PIC16C63 Rev. A Silicon Errata Sheet

The PIC16C63 (Rev. A) parts you have received conform functionally to the Device Data Sheet (DS30234D), except for the anomalies described below.

FIGURE 1: SCK PULSE VARIATION USING TIMER2/2

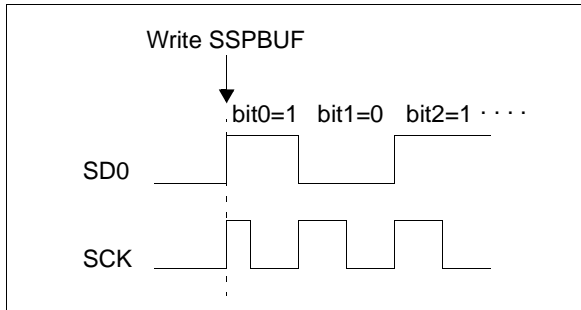
4. Module: SSP (SPI Mode)

When the SPI is using Timer2/2 as the clock source, a shorter than expected SCK pulse may occur on the first bit of the transmitted/received data (Figure 1).

To avoid producing the short pulse, turn off Timer2 and clear the TMR2 register, load the SSPBUF with the data to transmit, and then turn Timer2 back on. Refer to Example 1 for sample code.

FIGURE 1: WRITES TO TIMER1 (EXTERNAL CLOCK/OSCILLATOR MODE)

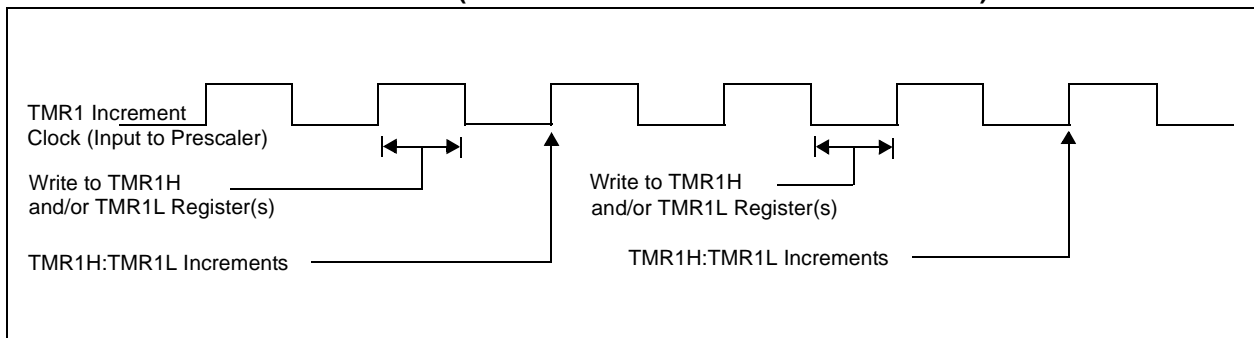
The operation of Timer1 needs some clarification when the timer registers are written when the TMR1ON bit is set.

The internal clock signal that is the input to the TMR1 prescaler affects the incrementing of Timer1 (TMR1H:TMR1L registers and the Timer1 prescaler). When the Timer1 registers are NOT written, the Timer1 will increment on the rising edge of the TMR1 increment clock.

When the TMR1H and/or TMR1L registers are written while this clock is high, TMR1 will increment on the next rising edge of this clock.

When the TMR1H and/or TMR1L registers are written while this clock is low, TMR1 will not increment on the next rising edge of this clock, but must first have a falling clock and the rising clock for TMR1 to increment.

Figure 1 shows the two cases of writes to the TMR1H and/or TMR1L registers. Due to the V_{IH} and V_{IL} thresholds on the oscillator/clock pins, external Timer1 oscillator components, and external clock frequency, the Timer1 increment clock may not be of a 50% duty cycle.
